ADDENDUM NO. 1

PRINCETON COMMUNITY PARK ELEMENTARY SCHOOL

Issued: January 16, 2026

FVHD PROJECT NO. 5516C

Drawing Name
FIRST AND SECOND FLOOR PLANS - WORK AREAS 'AC' & 'C'

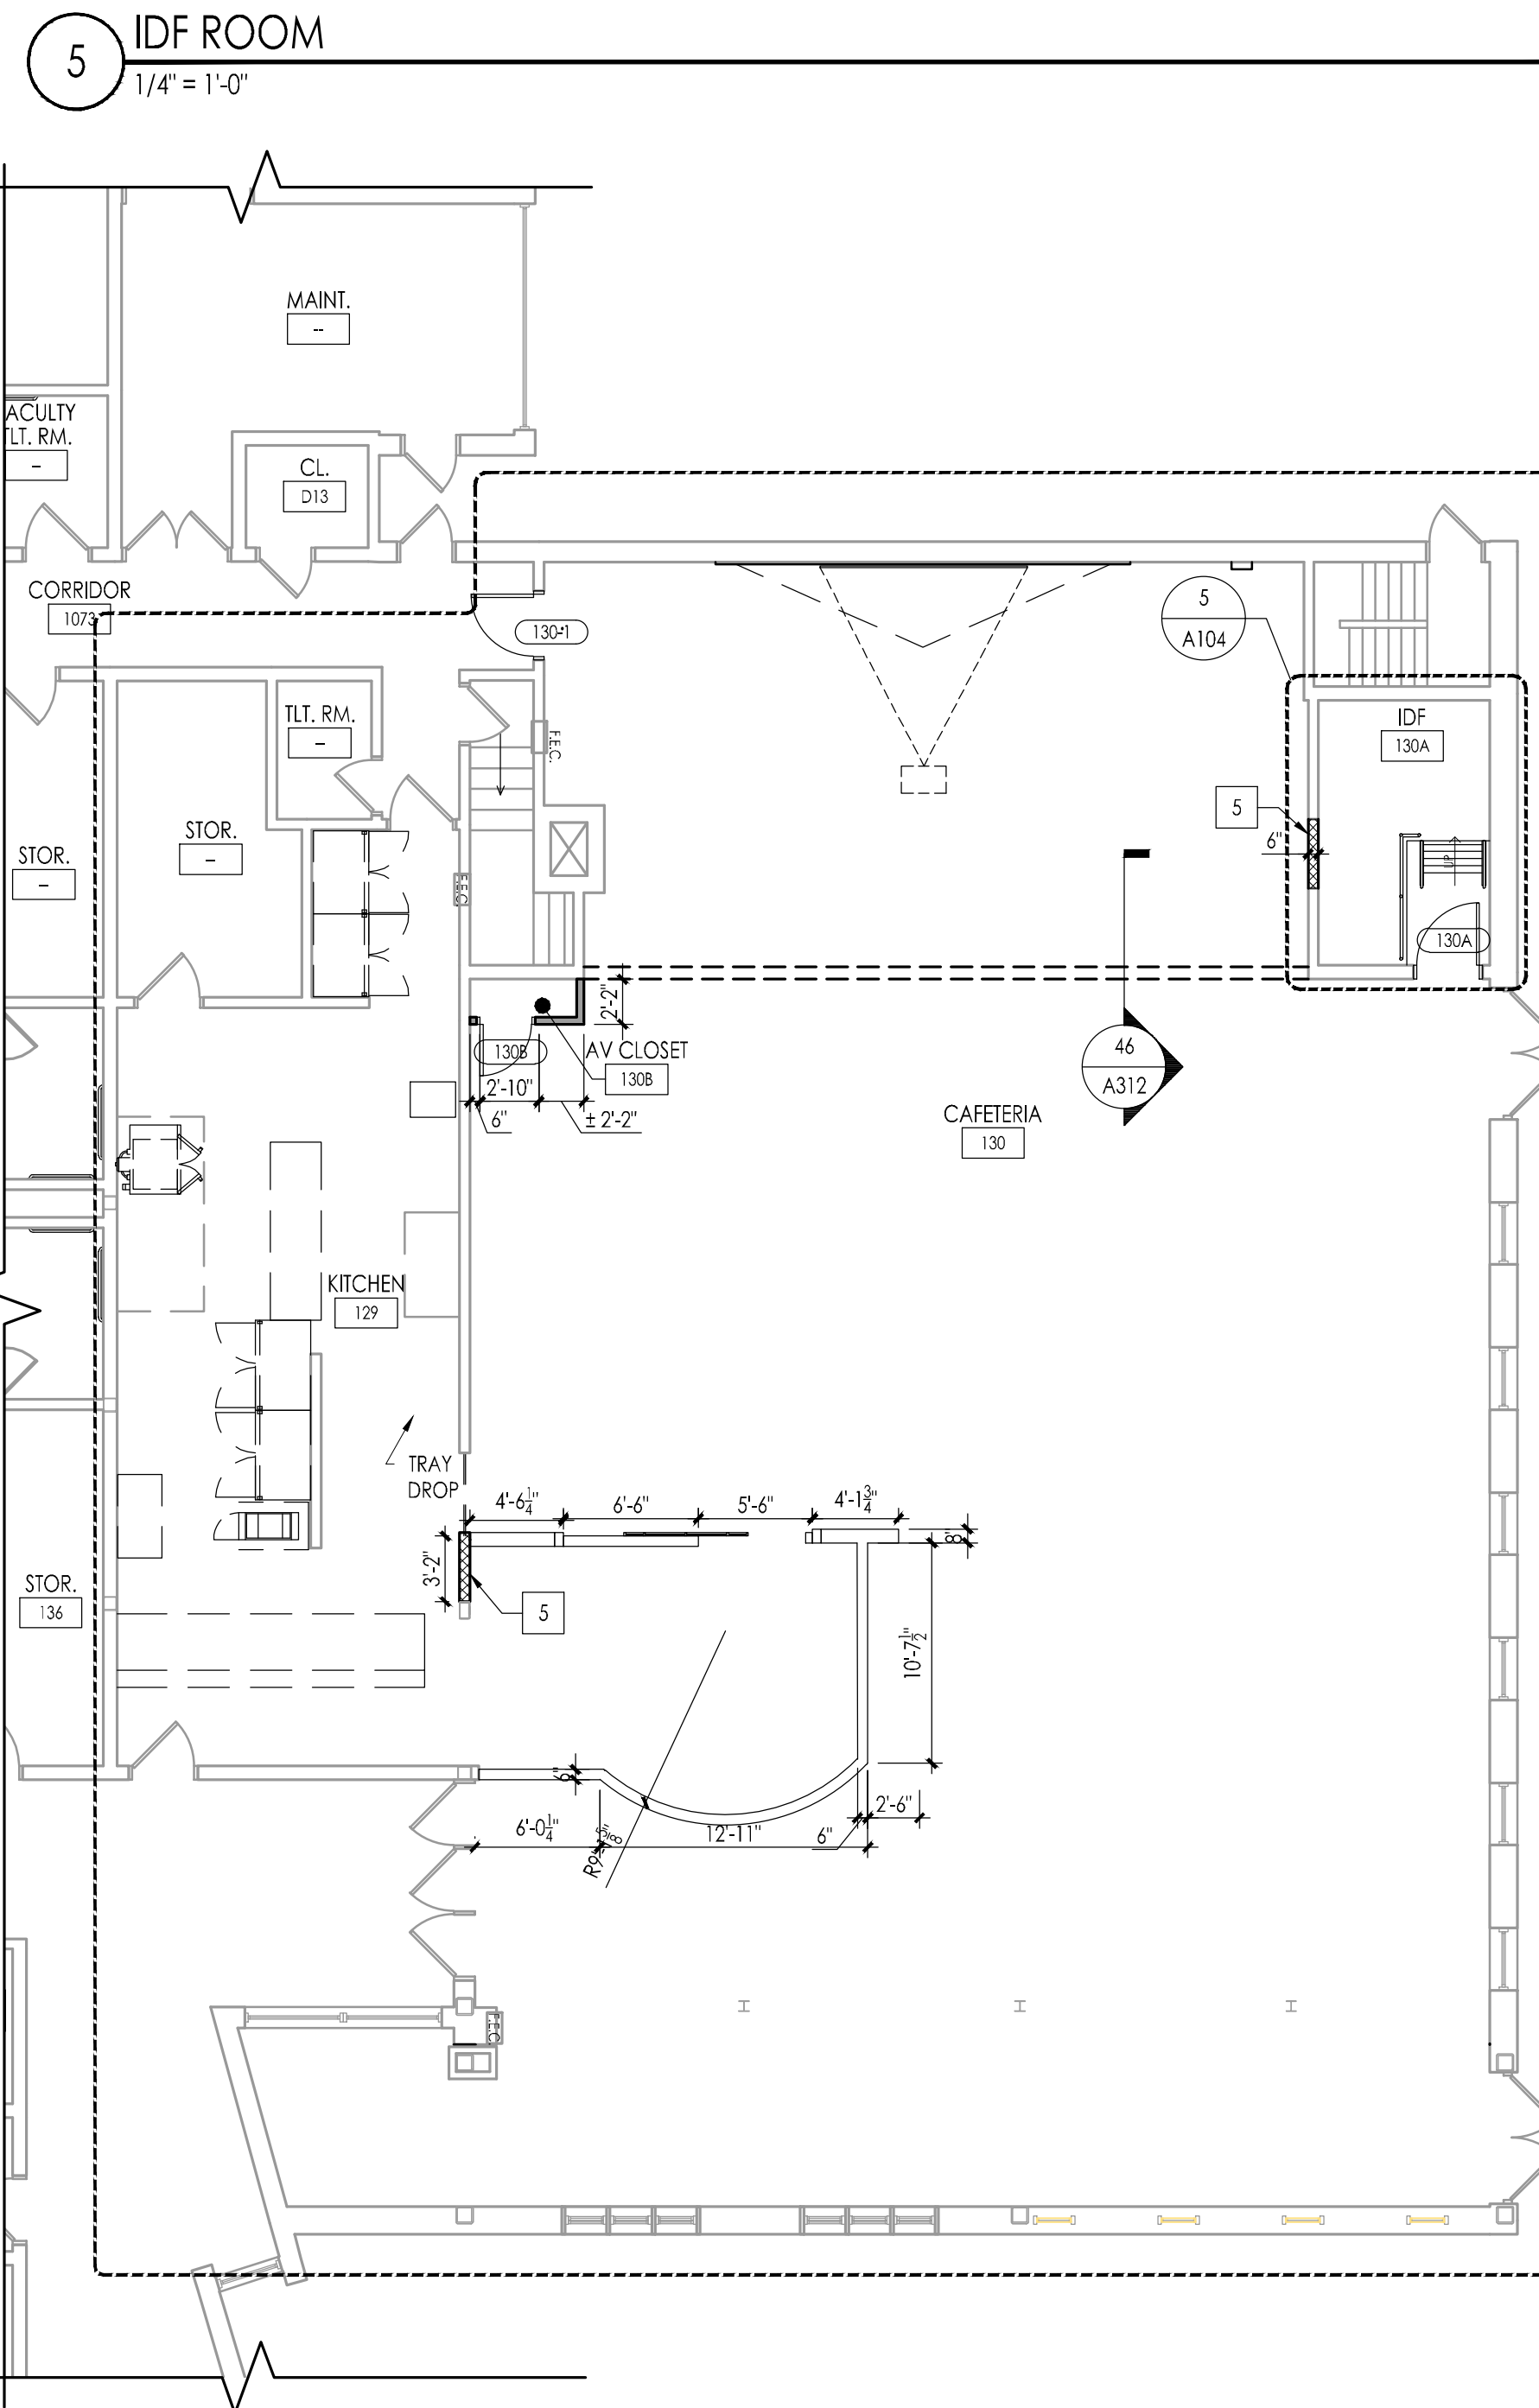
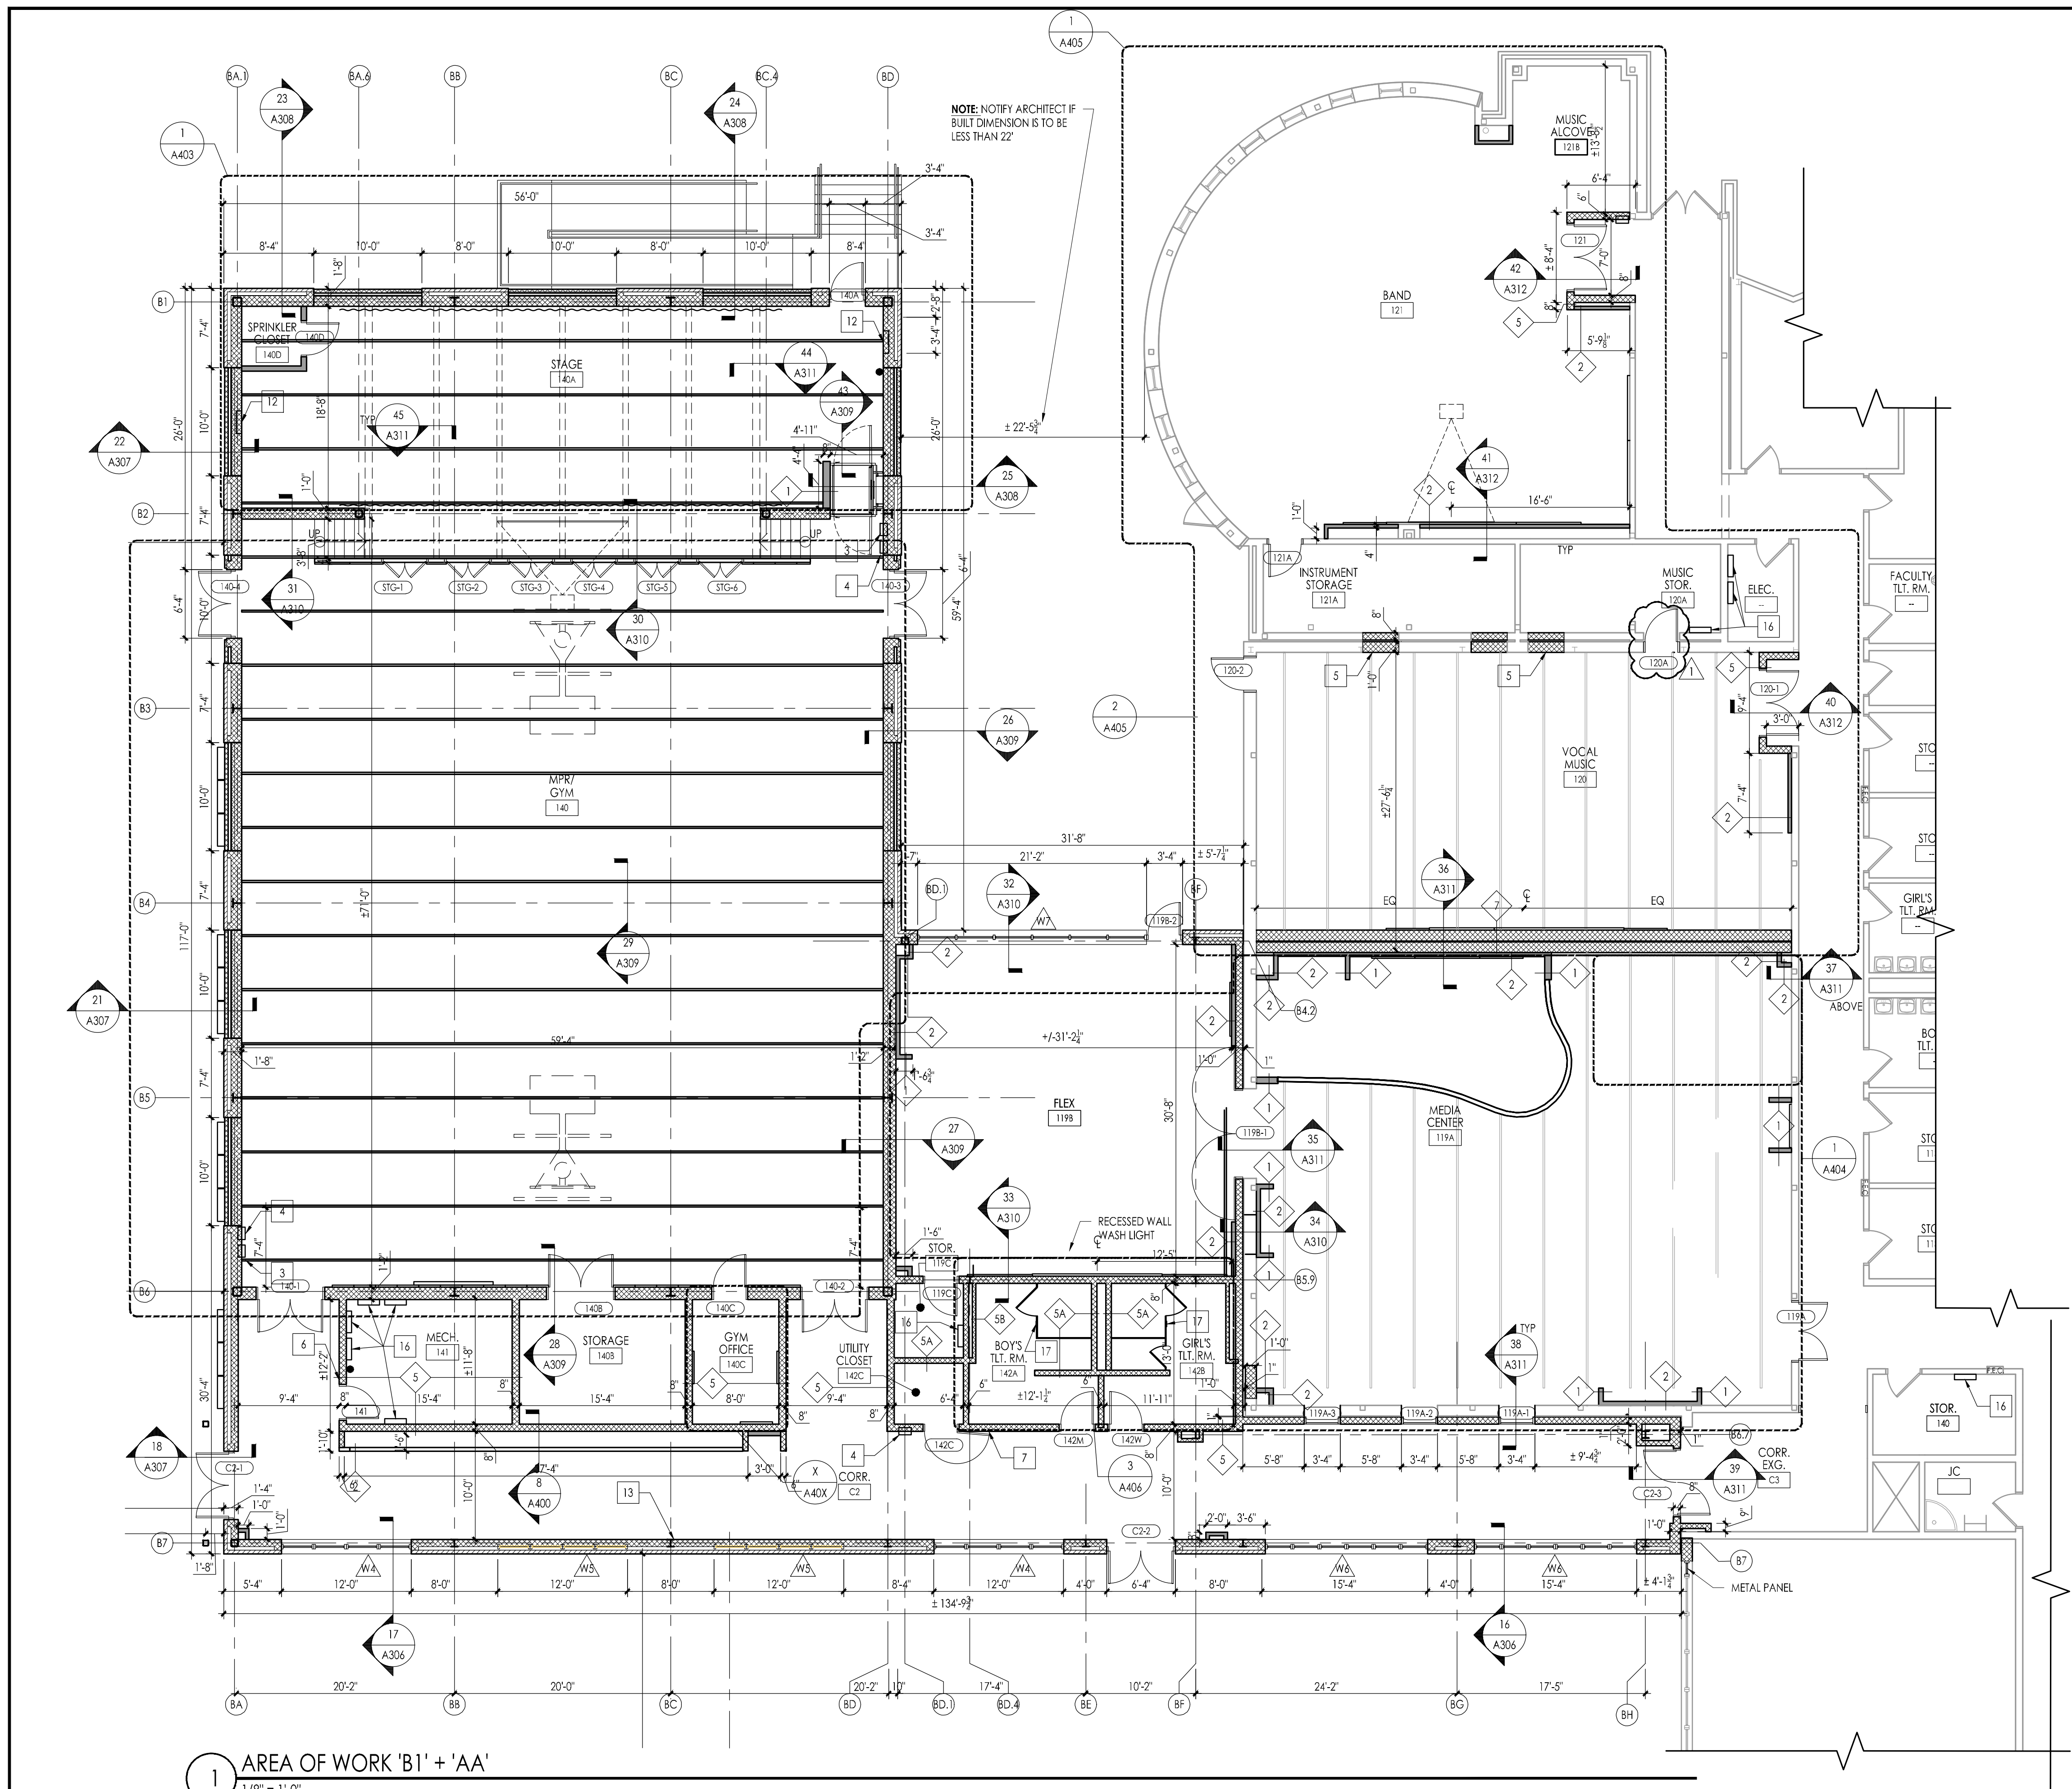
5. Question: "Pocket doors" – Specifications include pocket doors, pocket doors are NOT shown on drawings. Please confirm if they are to be included for all units

Response: Pocket doors are required at the recesses where the folding partitions are stacked when not deployed. See revised A103 attached to this Addendum.

Drawing Number
M1.0

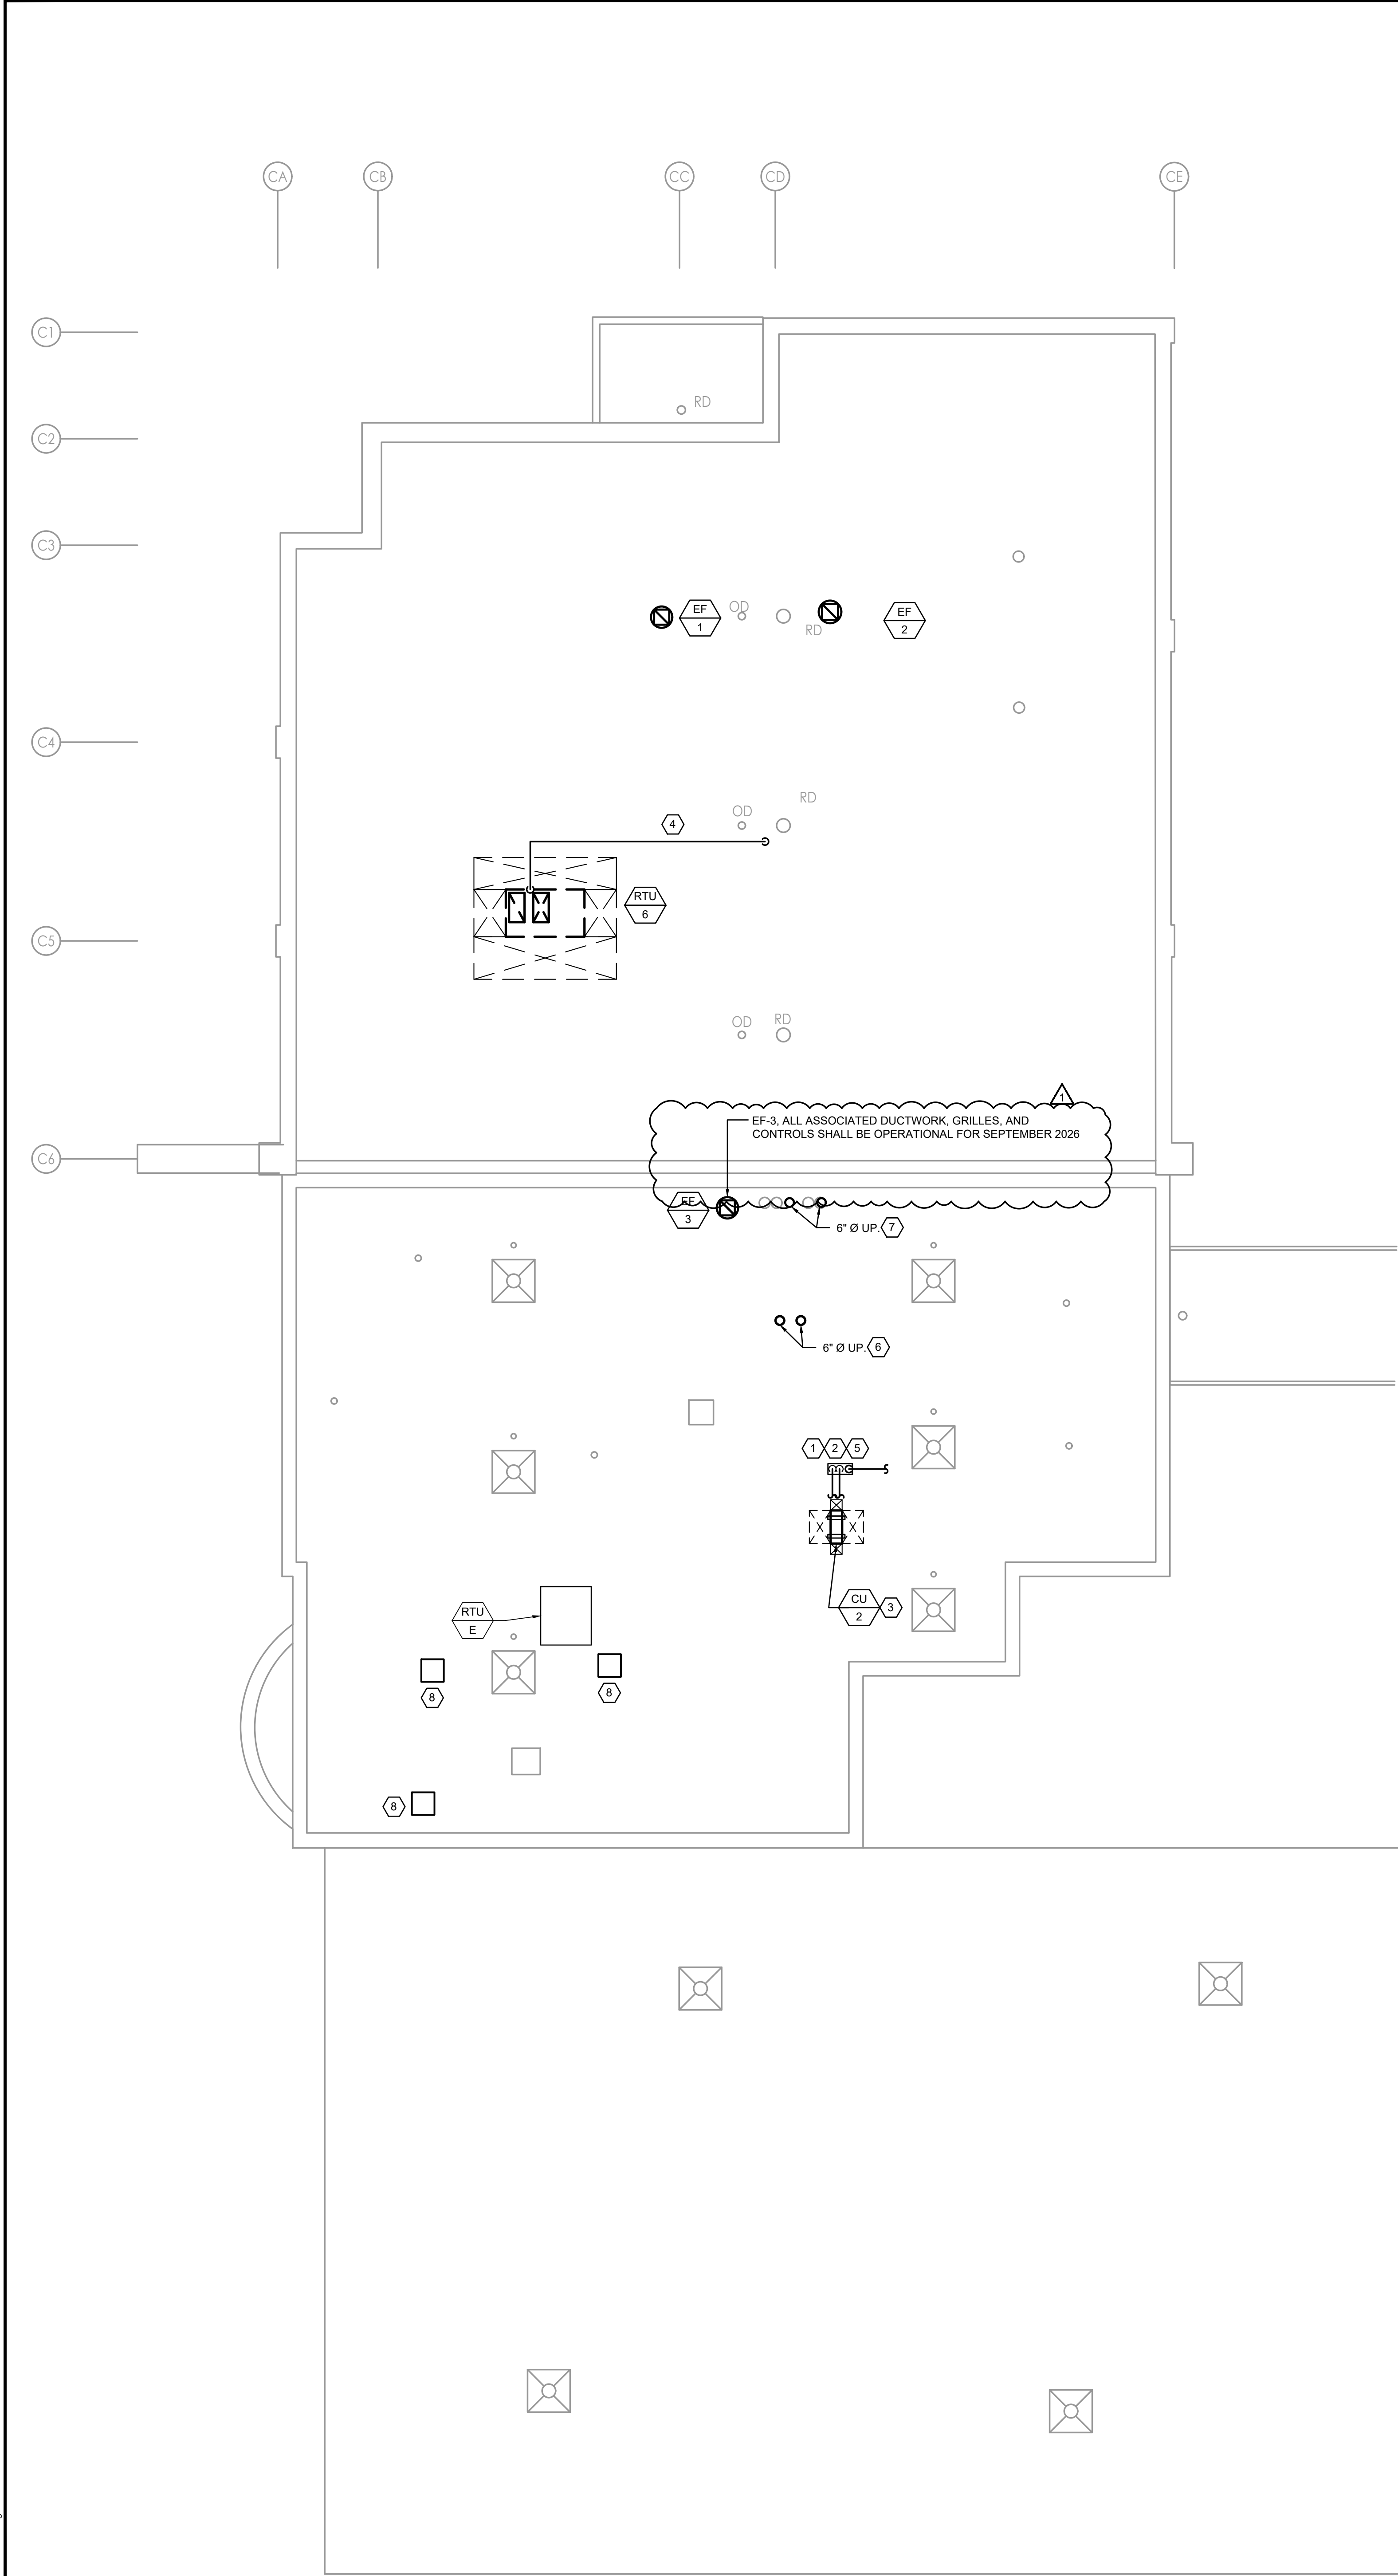
7. Question: Please provide the contact info for the existing Fire Alarm, Security & BMS Vendors.

Response: For Fire Alarm and Security, refer to Drawing E1.0, Electrical General Notes #83, 84 and 85 for Vendor Information. For BMS vendor, refer to revised drawing M-1.0, Mechanical General Note #30, attached to this Addendum.
